AGENDA

PLANNING & ZONING COMMISSION REGULAR MEETING WEDNESDAY, JANUARY 10, 2024 - 3:30 PM MCALLEN CITY HALL, 1300 HOUSTON AVENUE CITY COMMISSION CHAMBERS, 3RD FLOOR

3 TREE LOCATION DIAGRAM 1" = 40'-0"

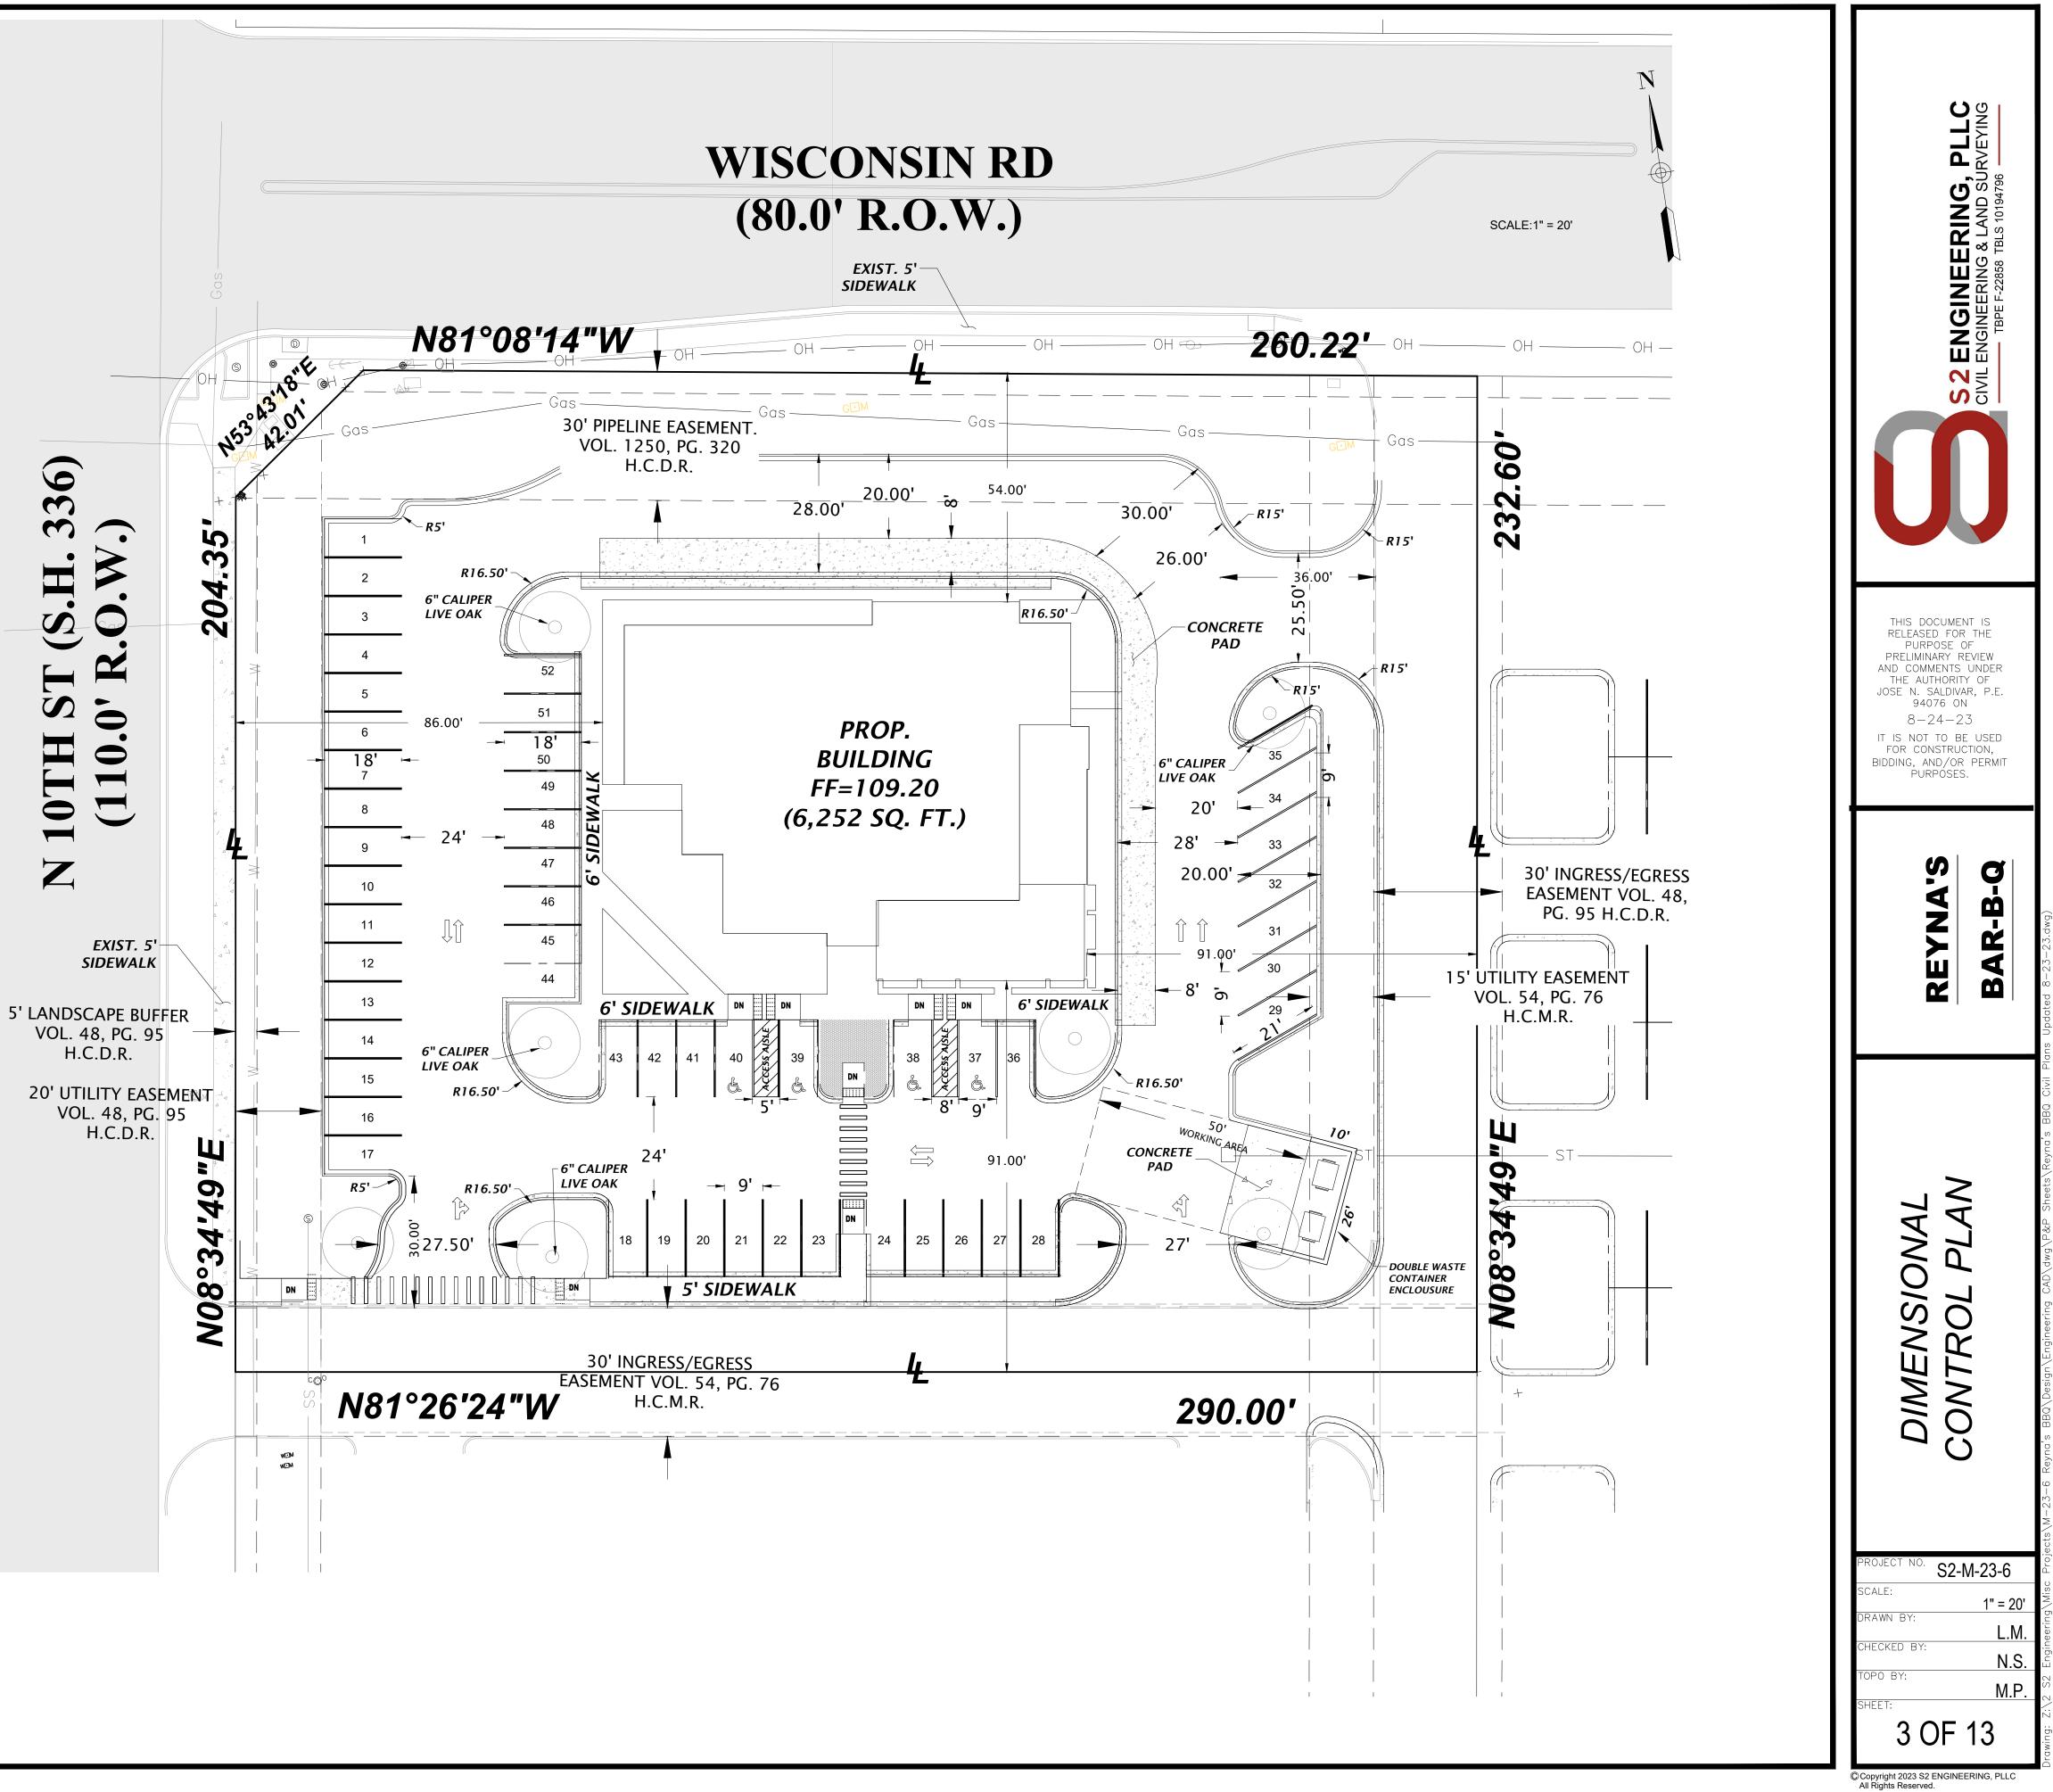
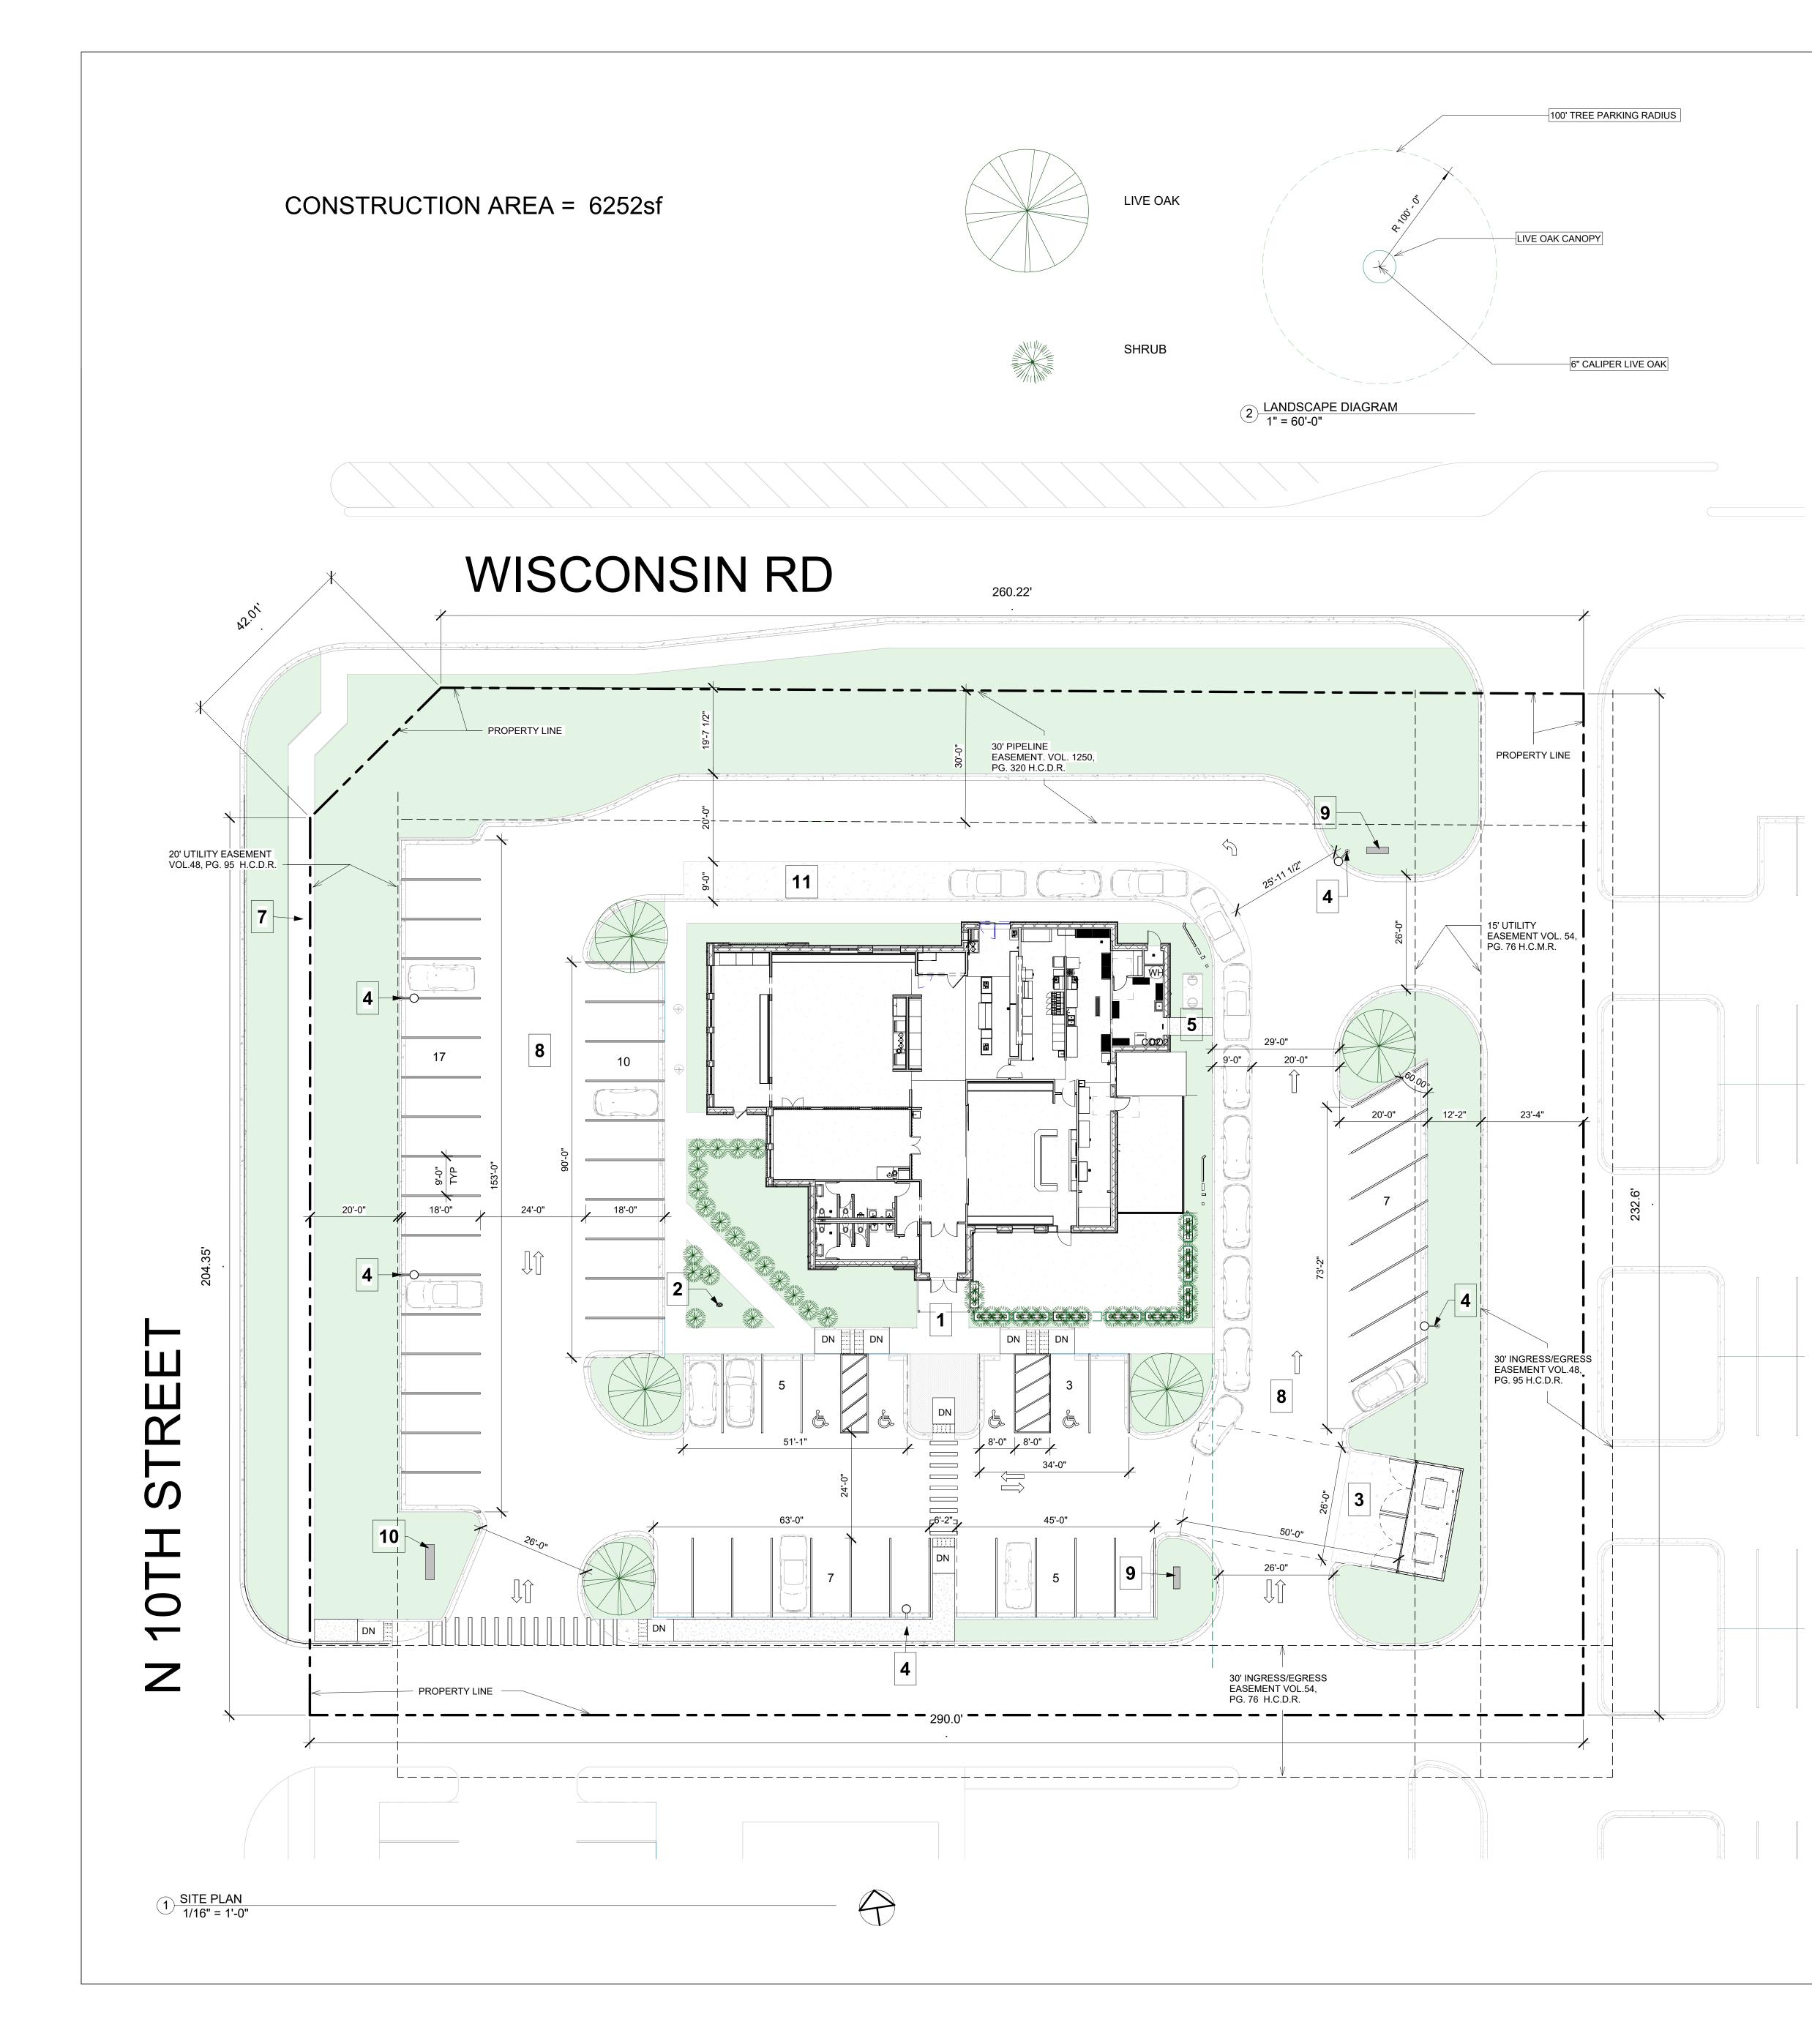
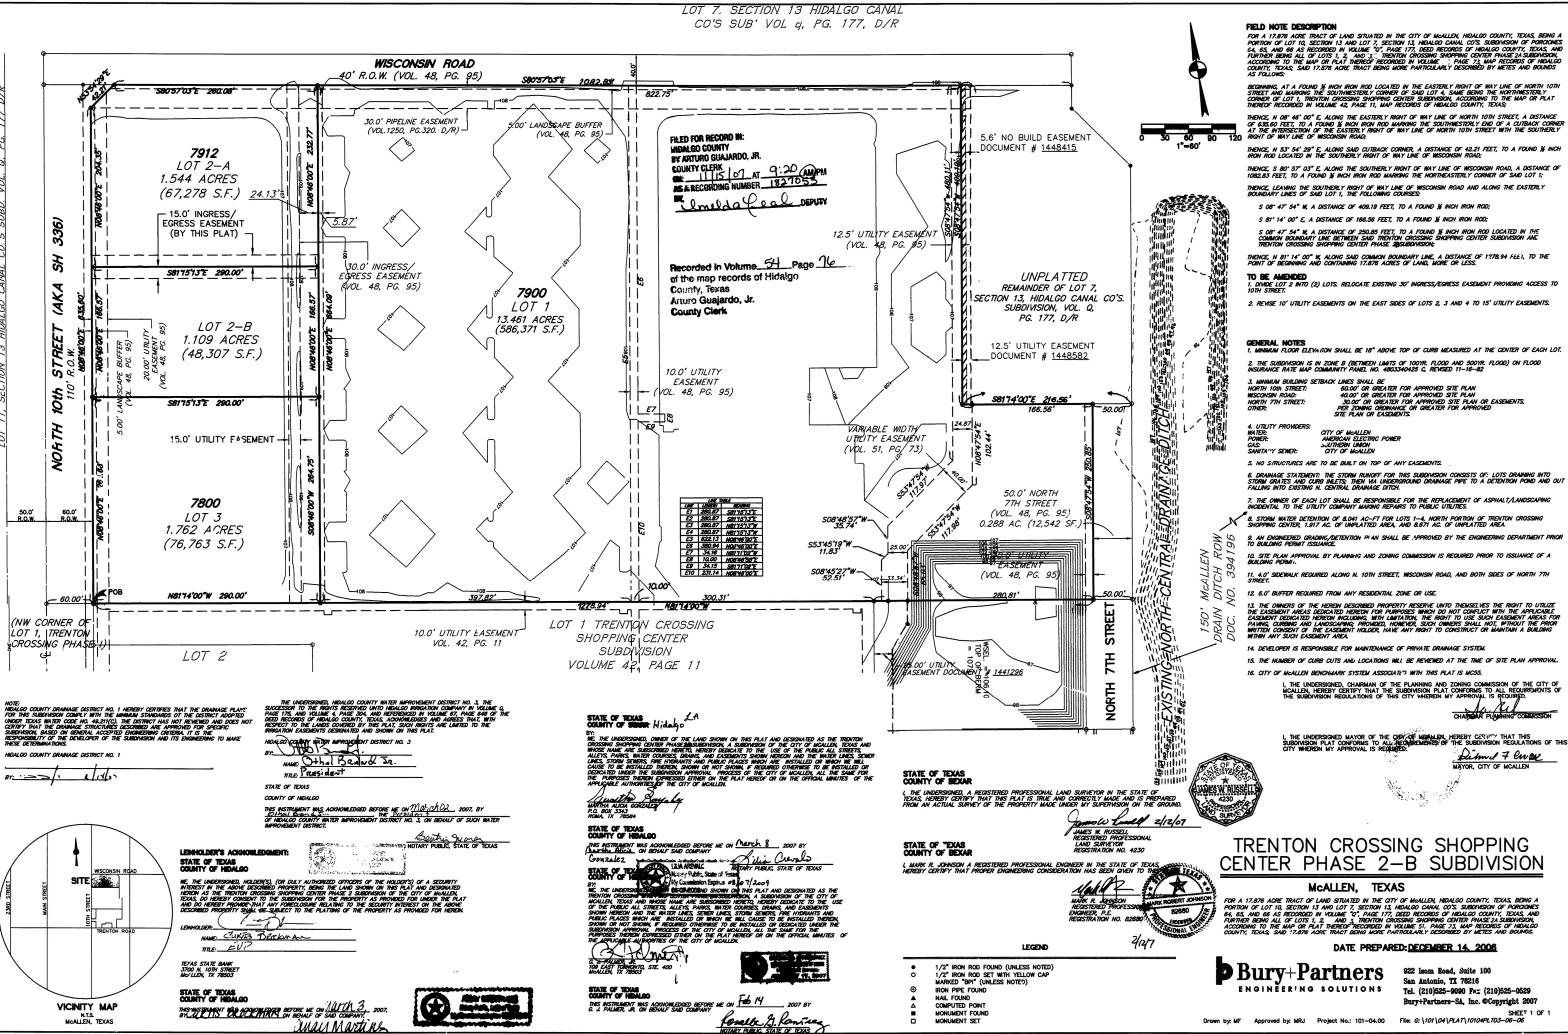
6727 square feet of green area is required for the new development and 17,135 square feet is proposed. The tree requirement is as follows: 20 two-and-a half-inch-caliper trees, 10 four-inch caliper trees, 5 six-inch caliper trees, or 8 palm trees. A minimum 10 feet wide landscaped strip is required inside the front property line. Fifty percent of the required green area for the new development must be visible from the street or front property line, and each parking space must be within 100 feet of a landscaped area with a tree. Finally, a 6-foot buffer is required around dumpsters/compactors if visible from the street. The applicant is meeting landscaping requirements for green area and trees.

There is a 60-foot front yard setback along North 10th Street, a 40-foot corner side setback along Wisconsin Road and other setbacks as per Zoning Ordinance or greater for approved site plan or easements. No structures are permitted to be built over any easements. The new development will be complying with all required setbacks for the property.

A 4-foot-wide minimum sidewalk is required along North 10th Street and Wisconsin Road.

The Building Permit Site Plan must comply with requirements noted on the Development Team Review sheet.
